# TRUCKS, 1/4 TON AND 3/4 TON, LANDROVER, ALL TYPES

PANELS, FRONT WING LEFT AND RIGHT HAND

UNIT REPAIR

FIG 1 - REINFORCING PLATE

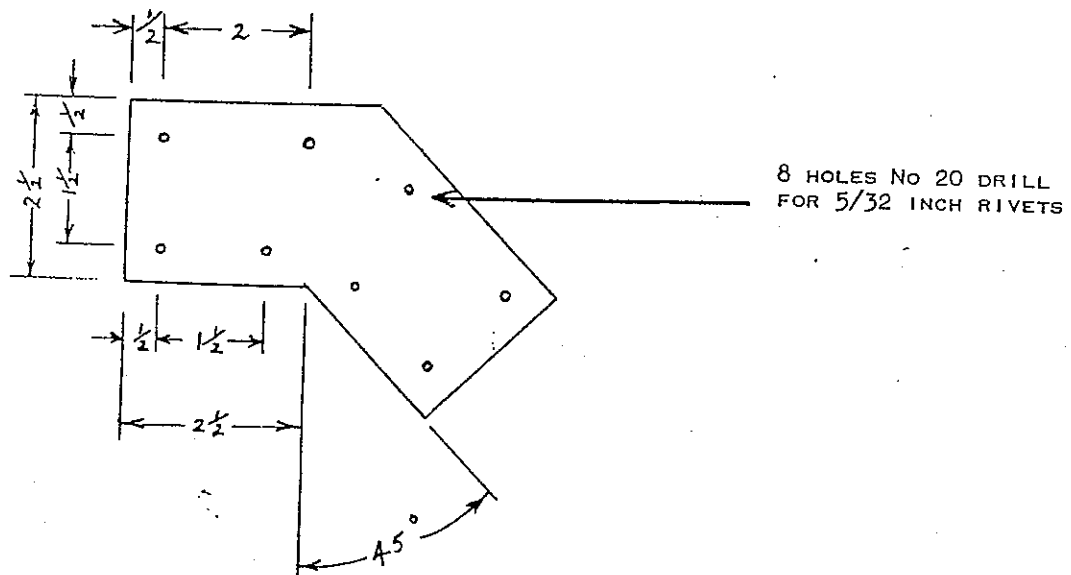
1. Cracking of the front mudguard rear well section has been noted.

2. When this occurs it will be repaired as follows:-
  - (a) Manufacture a support plate as shown in fig 1, using 12 SWG Aluminium Plate AS H48-75-H34 (AA-M578-1/2H).
  - (b) Drill 1/8 inch diameter hole at the end of the crack.
  - (c) Rivet the plate, on inside of wing panel at the corner where the cracking occurs, using 5/32 inch aluminium pop-type rivets.

NOTE:- Wing panels having cracks longer than 2 1/2 inch will require larger reinforcing plates.
